## Addendum #02

**PROJECT:** Coit Arts Academy – Phase 2 Summer 2025 Work  
617 Coit Ave NE  
Grand Rapids, MI 49506

**Addendum No.** 02

## Addendum # 2

COVER SHEET

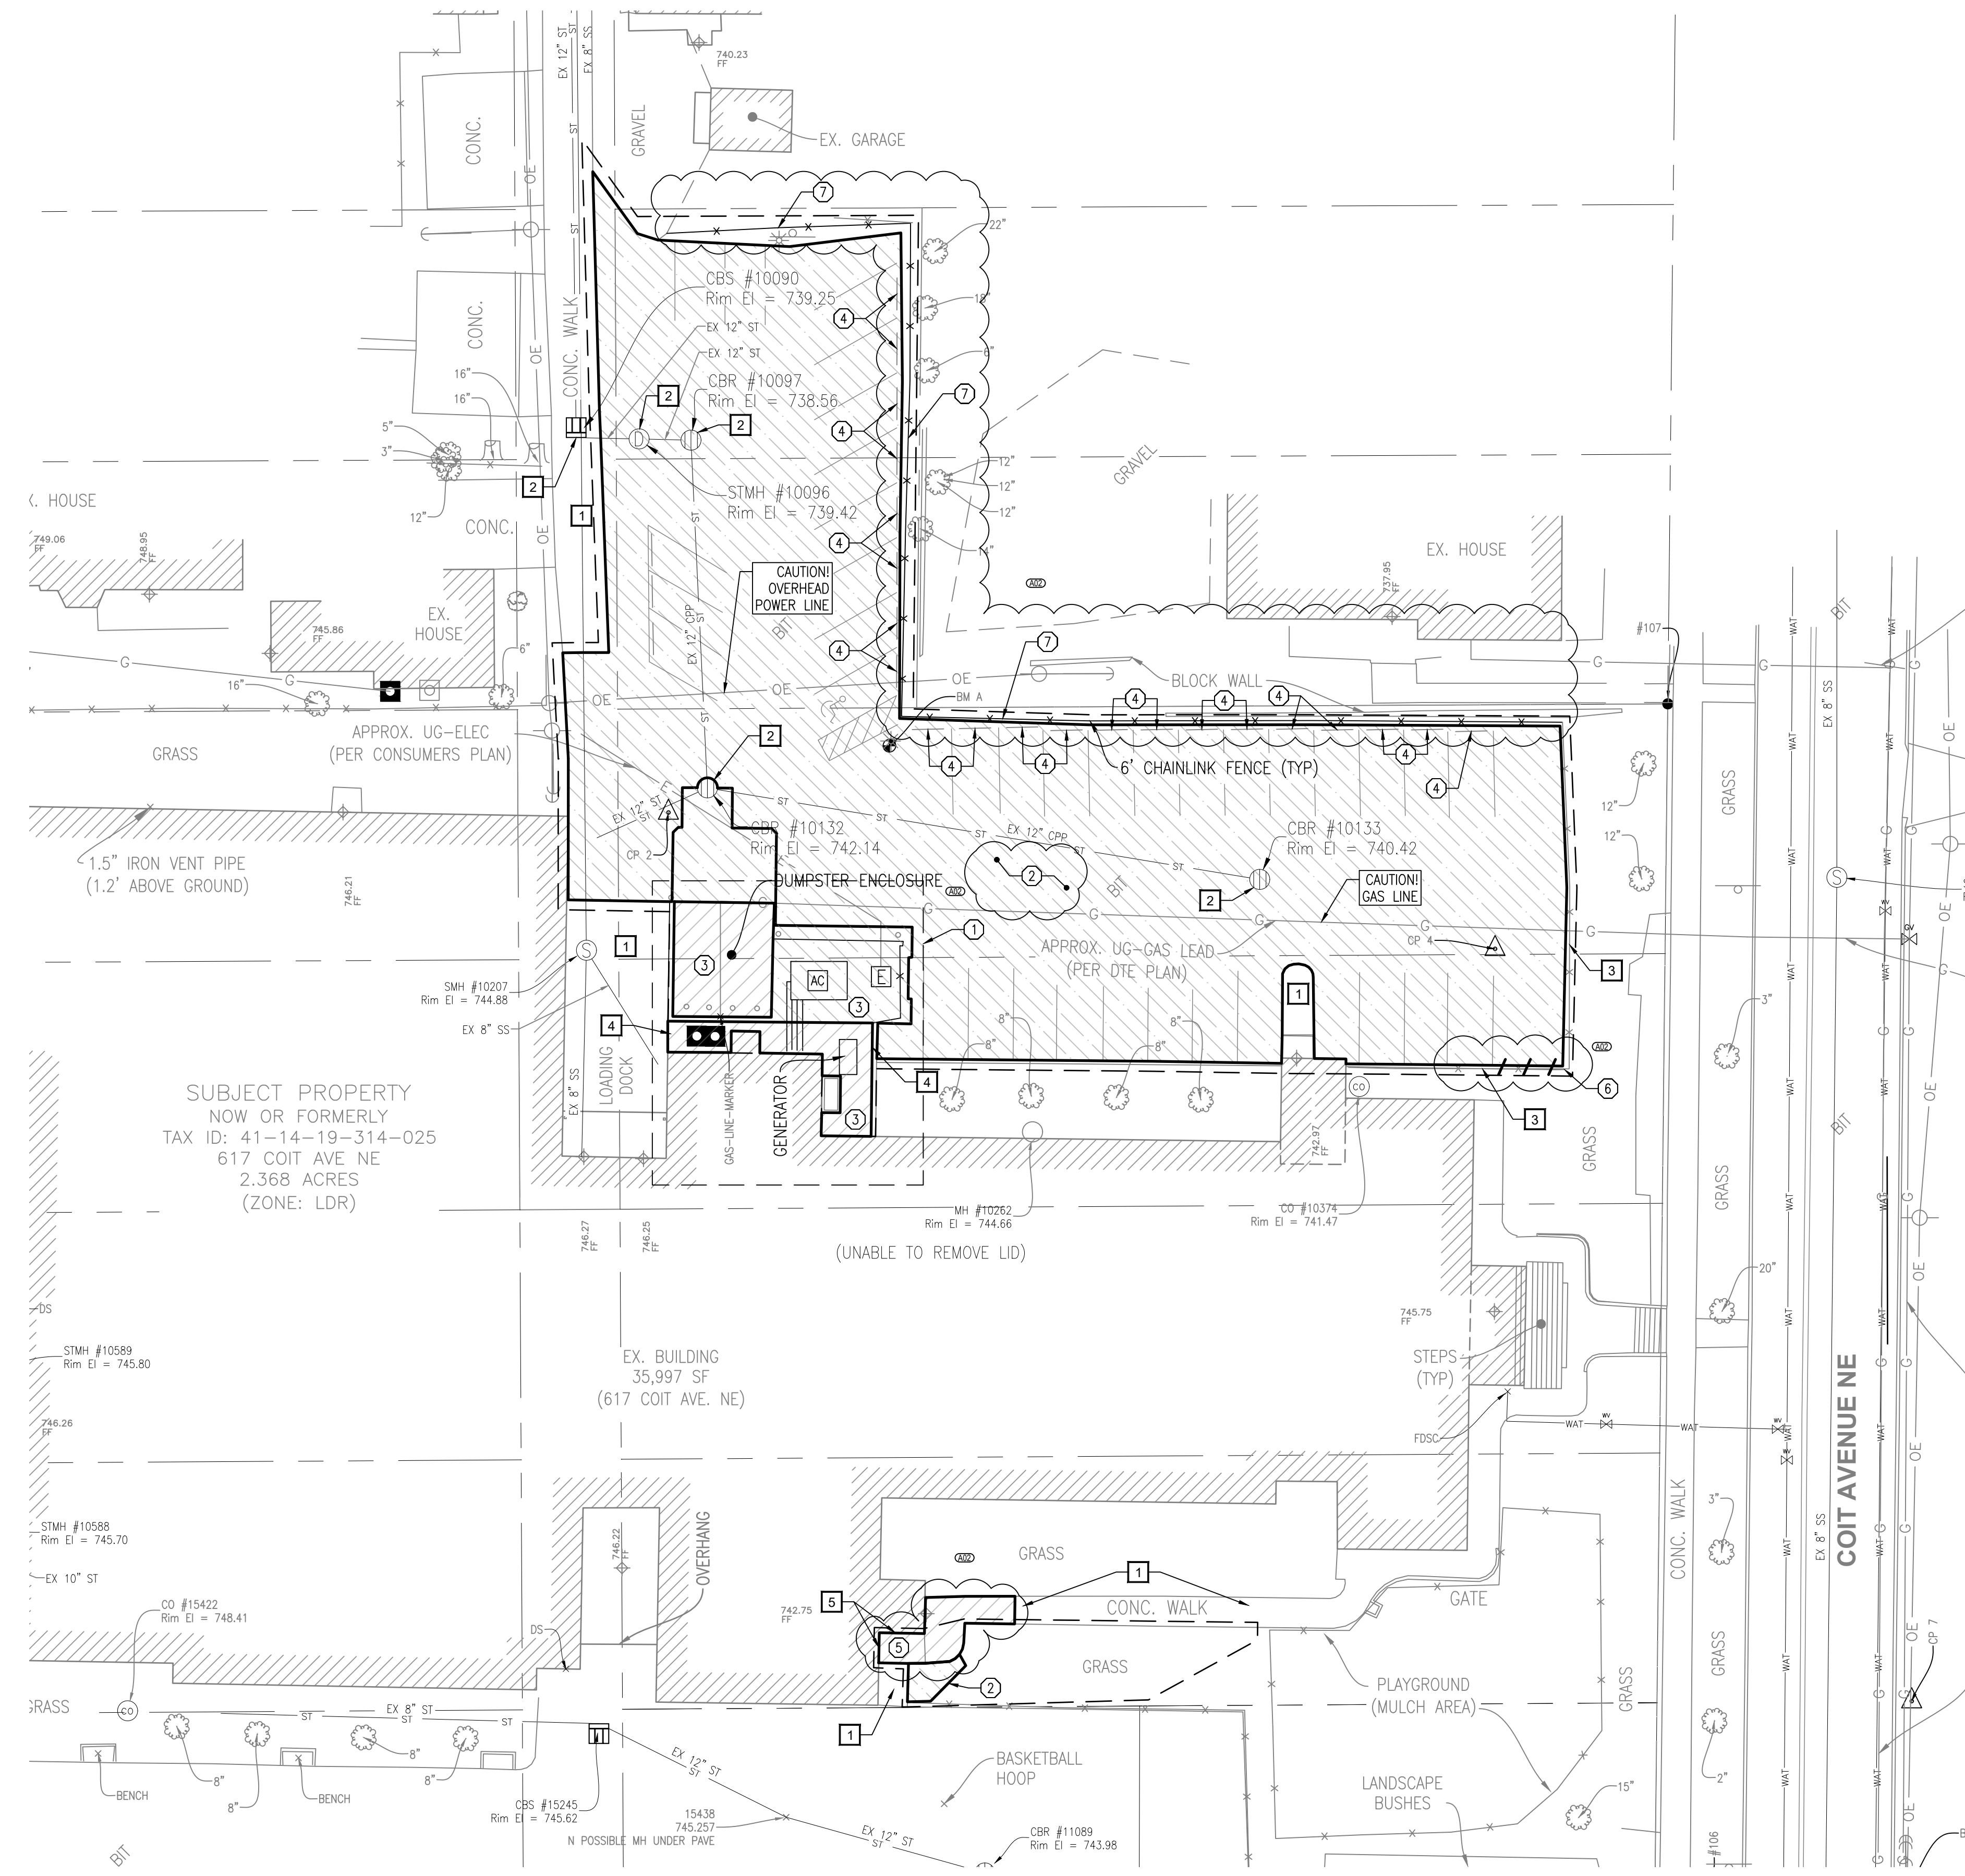
- A2.7 Refer to Sheet G-001.2 (reissued):  
Revise Alternate Bid #3 description. Add new sheets.

**C-102.2**

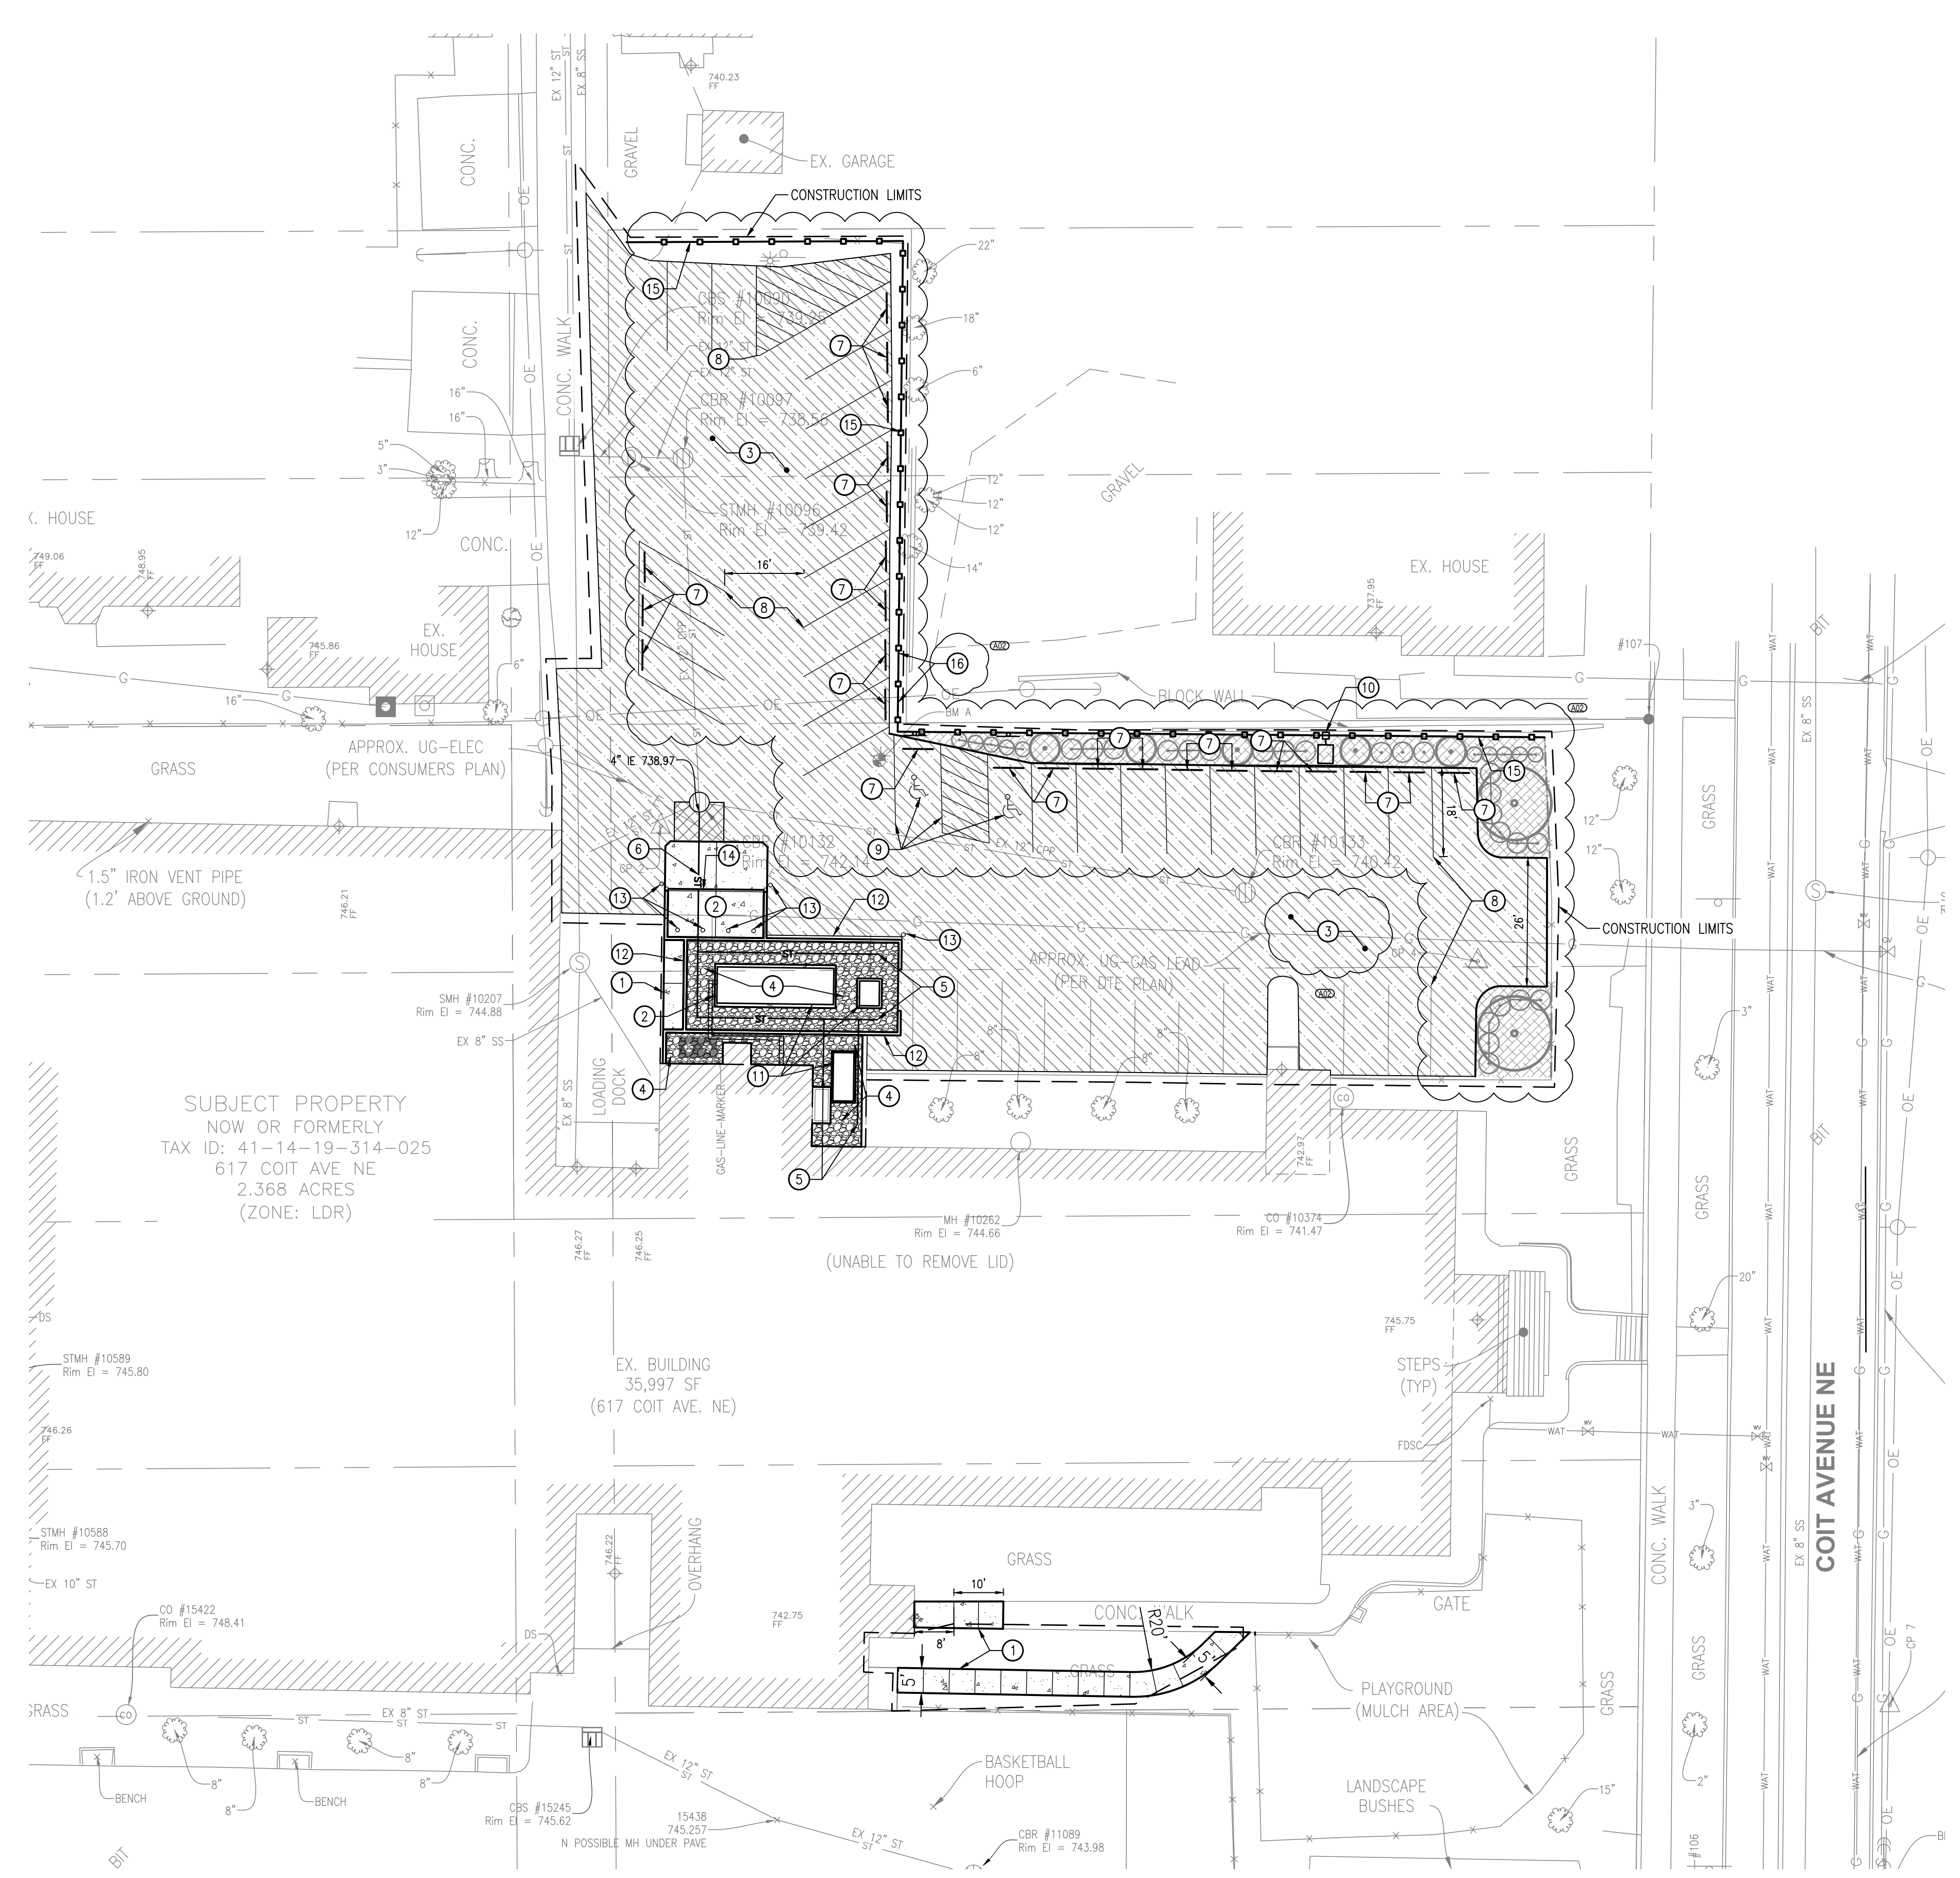
- A2.9 Refer to Sheet C-102.2 (reissued):  
Revise HMA section to be Heavy-Duty asphalt. Revise parking layout. Add privacy fence. Add reserved parking signs.

**LANDSCAPE PLAN**

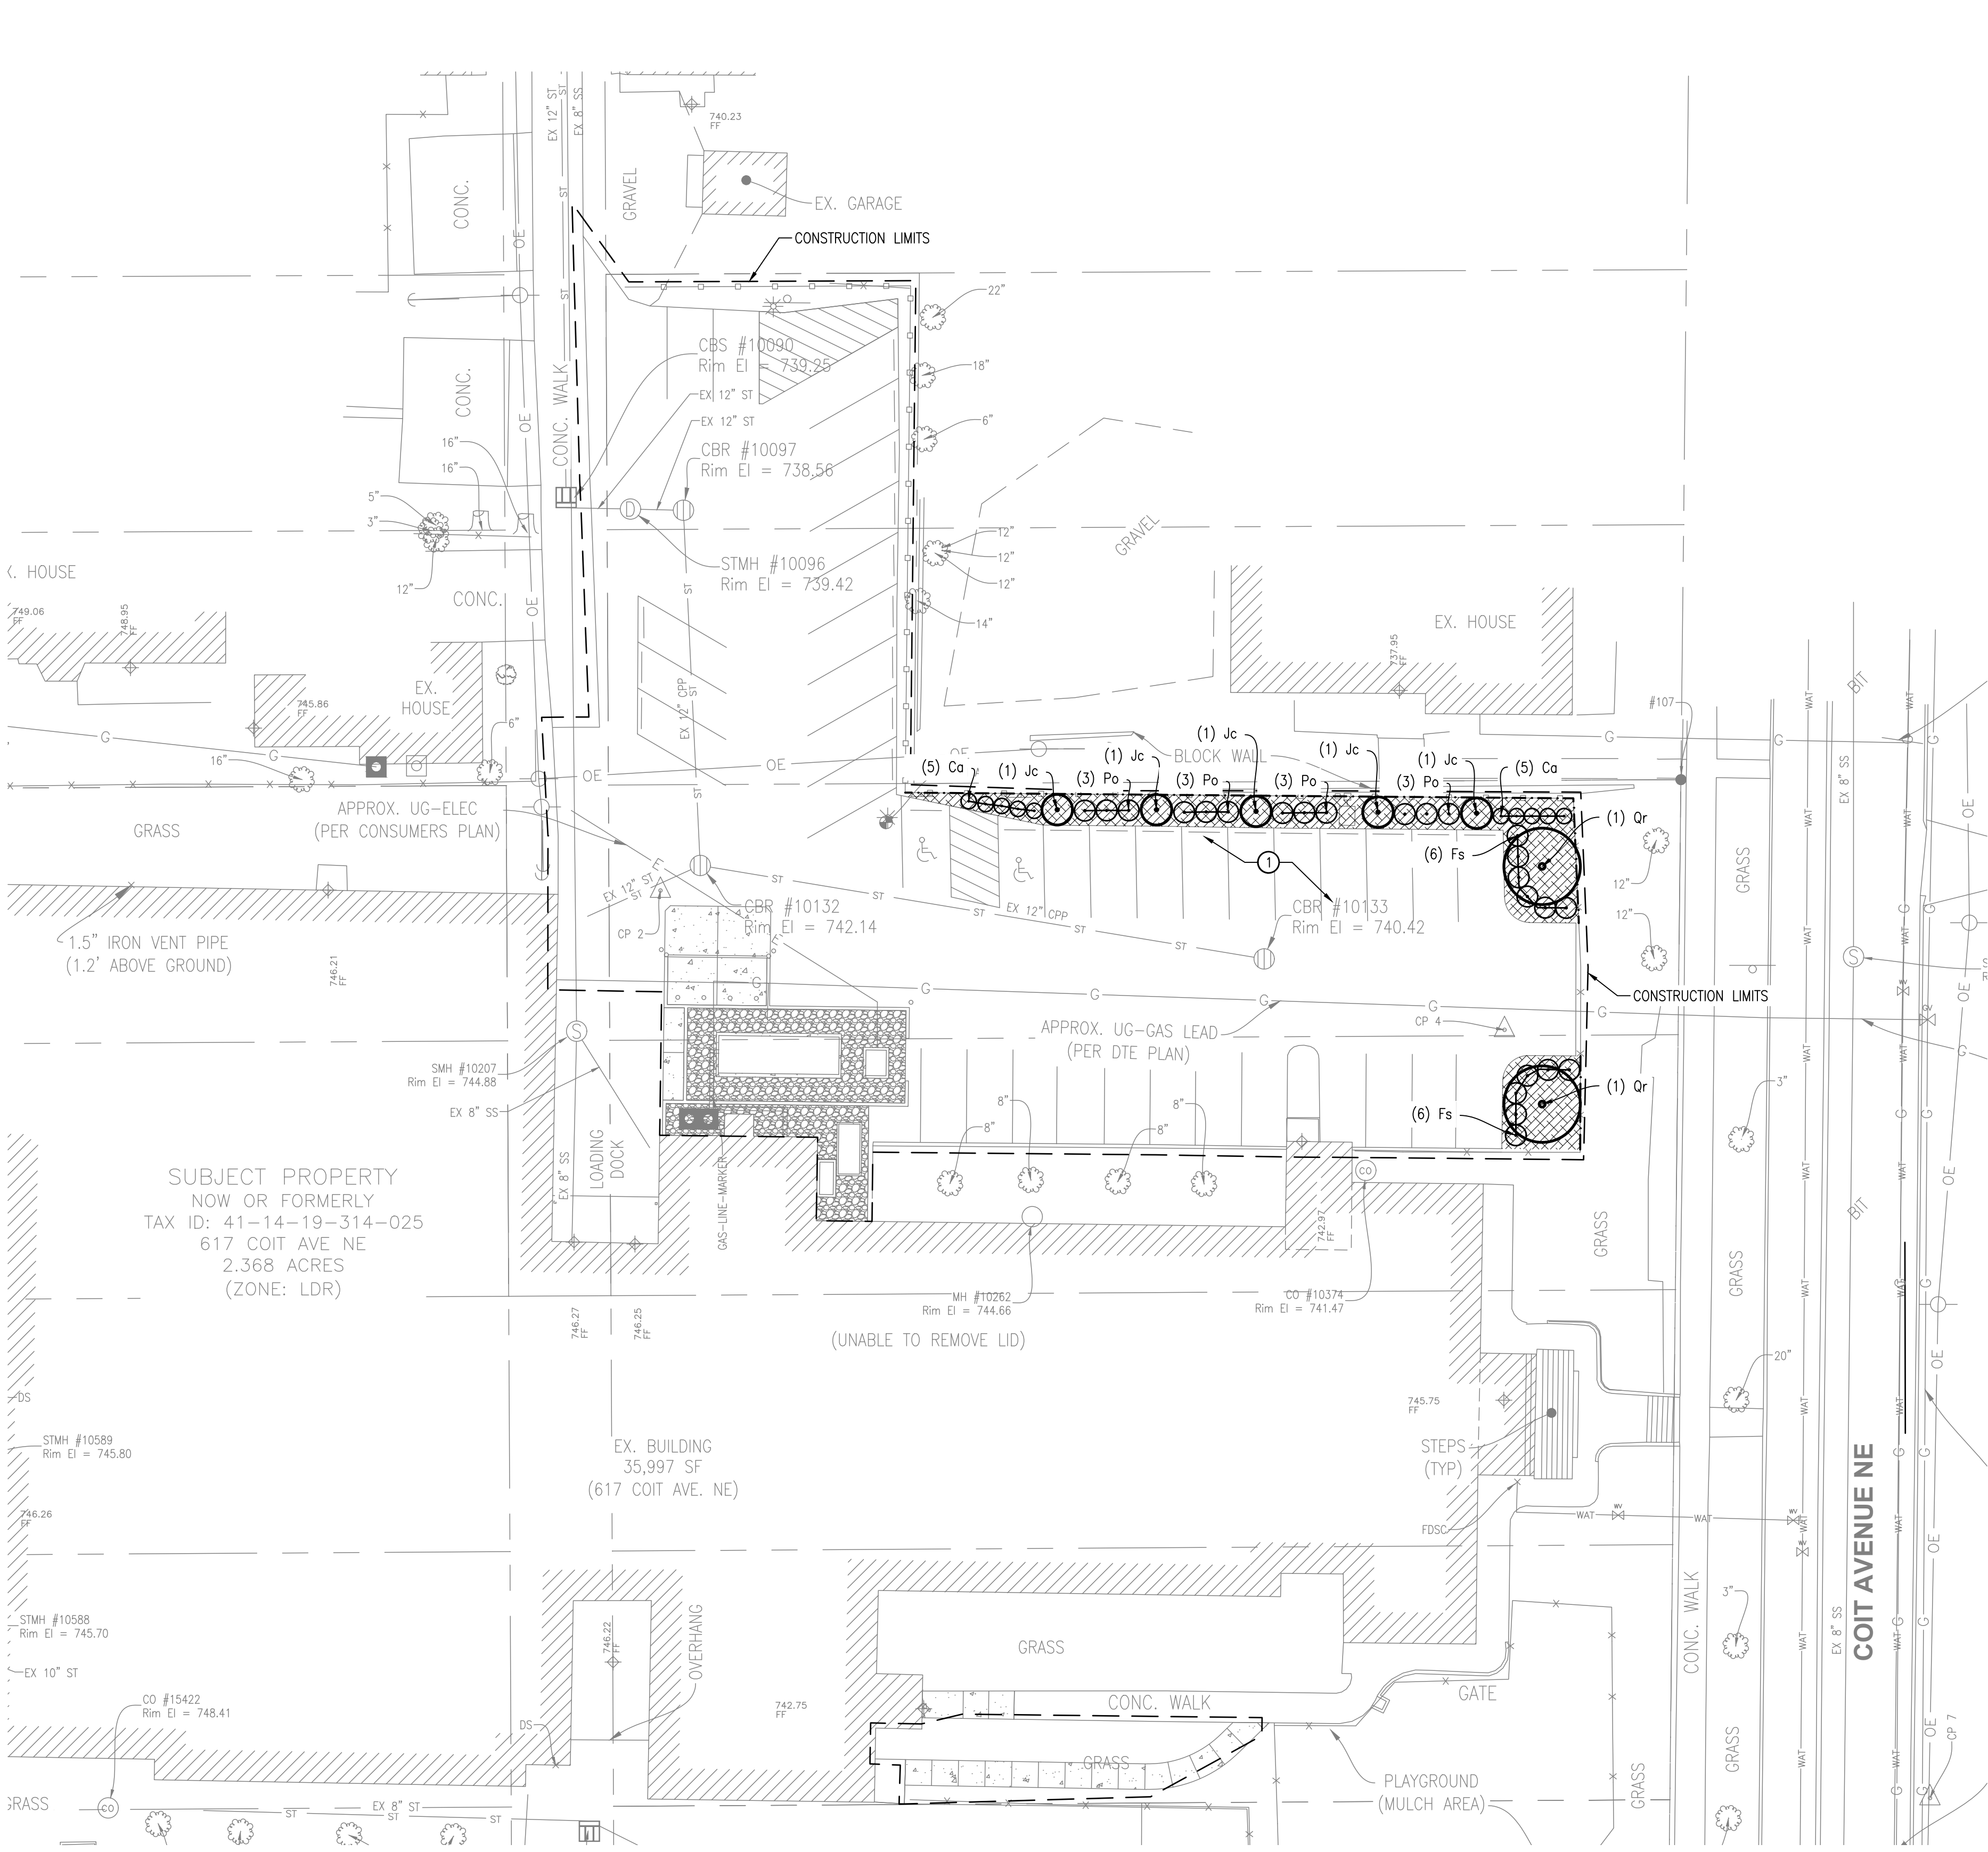
**31** *Include Landscaping as shown on added sheets L.100.2, L-500.2. (Add. 2)*

- A2.12 Refer to Sheet L-100.2 (issued):  
Issue new sheet in its entirety. Add mulch areas, tree trimming, soil amendment, and planting of trees, shrubs, and grasses.
